Access Compliance Report

Public Rights-of-Way

Intersection ID: 10040845	Main Street: WAKEFIELD_DR	Cross Street: N/A	Location: NE
ADA ID: EDFB94C6A5DA	Ramp Type: Perp	Initial Pass/Fail: Fail	Overall Compliance: No
Codes/Mitigation Info/Possible Solution		Field Measurements/Component Compliance	
Severity Score: 8.75

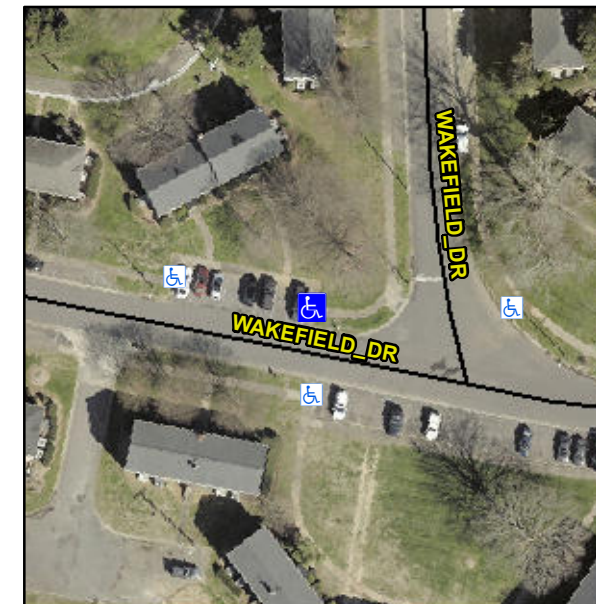
Compliance	Description	Data	Compliance	Description	Data
N/A	Ramp Length (in)	59.0	Yes	Ramp Slope (%)	6.9
No	Ramp Width (in)	47.0	Yes	Ramp XSlope (%)	1.6
N/A	Flare Type LT	N/A	N/A	Flare Type RT	N/A
N/A	Flare Slope LT (%)	N/A	N/A	Flare Slope RT (%)	N/A
N/A	Flare Traversable LT?	N/A	N/A	Flare Traversable RT?	N/A
N/A	Landing Length (in)	N/A	N/A	DWS Provided?	N/A
N/A	Landing Width (in)	N/A	N/A	DWS Contrast?	N/A
N/A	Landing Slope (%)	N/A	N/A	DWS Length (in)	N/A
N/A	Landing X Slope (%)	N/A	N/A	DWS Full Width?	N/A
N/A	Landing Curb? (Y/N)	N/A	N/A	DWS Offset (in)	N/A
N/A	Shared Landing?	N/A			
N/A	Gutter Ponding?	N/A	N/A	Gutter Slope (%)	N/A
N/A	Gutter Lip Ht (in)	N/A	N/A	Gutter X Slope (%)	N/A
N/A	Painted X Walk1?	No	N/A	Painted X Walk2?	N/A
	X Walk 1 Direction	To NW		X Walk 2 Direction	N/A
N/A	X Walk 1 Width (in)	N/A	N/A	X Walk 2 Width (in)	N/A
	X Walk 1 Slope (%)	1.8		X Walk 2 Slope (%)	N/A
	X Walk 1 X Slope (%)	1.8		X Walk 2 X Slope (%)	N/A

Remove & Replace Entire Ramp.
